REQUEST FOR PROPOSALS FOR THE FIRST 5 LA (CIP) CAPITAL IMPROVEMENT PROJECT

QUESTIONS AND ANSWERS FROM DESIGN-BUILD SITE VISITS

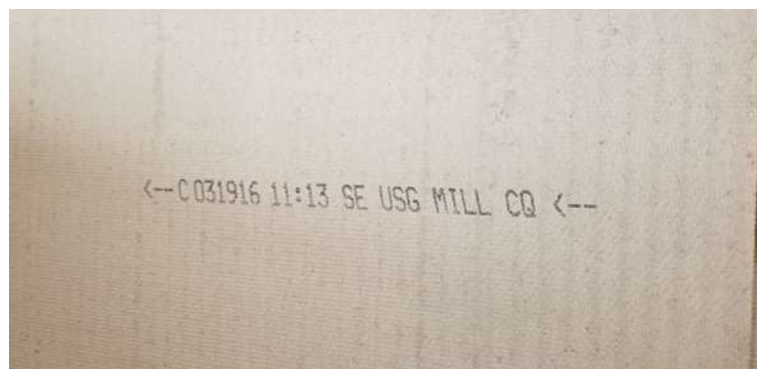
Q67: Confirm the locations show on A3.01 an A3.02 represent the full scope of plaster cracking and window gasket failure.

A67: The location and quantity of Plaster cracks need to be field verified by contractor. Provide allowance if accurate quantity of Plaster cracks cannot be verified. The location of window gasket failure is accurate based on design team's field verification. Any other **additional** remedy related works needed will be handled under Allowance.
